IEEE-STD-1658 DAC STANDARDS WORKING COMMITTEE

03 June 2009, 09:00 – 17:00

Figure IV – Block Diagram of DAC and Interpolator that is used to Describe DAC Dynamic Response. If  $K = 1$ , the DAC Operates as a Classic DAC

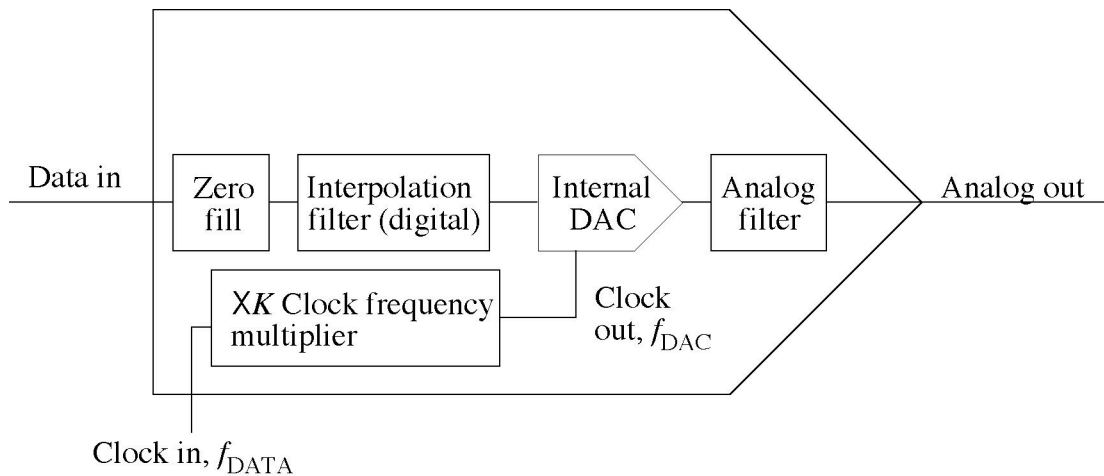
Figure IV was modified by Solomon Max (assignment # 14), but was not available for review at the meeting the modified Figure IV is shown below;

The definitions of update rate and clock rate used in section 6 should be the same as those used in Figure IV.

The figure defines the DAC analysis of bandwidth. If  $K=1$  then the DAC is a classic DAC where the internal DAC inputs are identical to Data in.
